# Petition No. 1454 The Connecticut Light and Power Company d/b/a Eversource Energy Mansfield Substation, 140 North Eagleville Road, Mansfield, Connecticut Staff Report July 23, 2021

# **Proposed Project**

Figure 1. Site location with staging/laydown areas off North Eagleville Road.

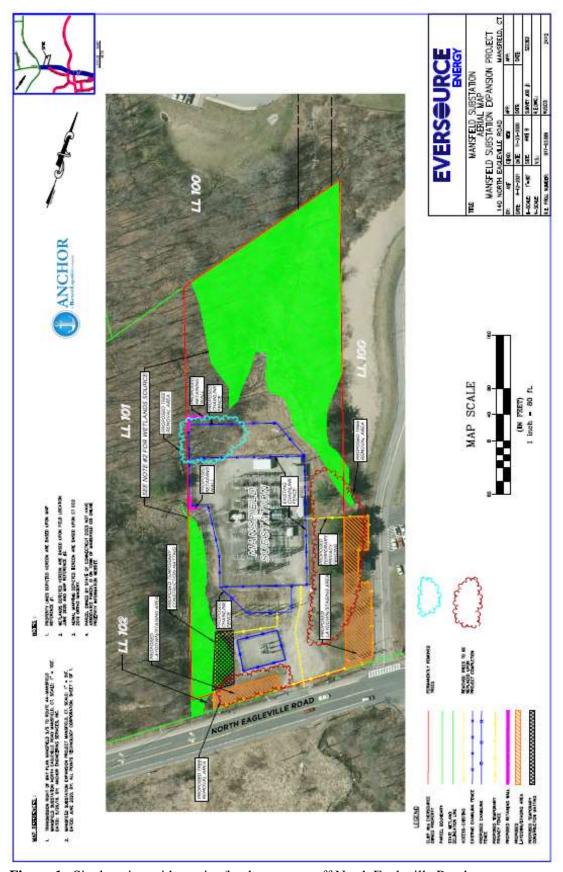
Eversource would utilize staging/laydown areas on UCONN property that abuts the substation. Such staging/laydown areas would be located on the southern and southeastern sides of the substation and would total approximately 39,430 sf in size. Eversource would access these staging/laydown areas from North Eagleville Road. These staging/laydown areas would be used for construction trailers, storing construction materials, equipment, tools, fuel, and supplies. A temporary fence would be installed on the southern and southeastern sides of the existing substation fence to define these areas and secure the construction equipment.

To accommodate the laydown/staging areas located off of North Eagleville Road, Eversource would remove approximately 9 dogwoods, 8 white pines, and 2 eastern red cedar trees. Eversource is working with UCONN to develop a replanting plan. The replanting plan is expected to be finalized by November 2021. The laydown area at 25 LeDoyt Road would not require tree clearing.

- 1. Approval of any project changes be delegated to Council staff; and
- 2. A copy of the final planting plan for the staging/laydown areas off of North Eagleville Road be submitted to the Council.
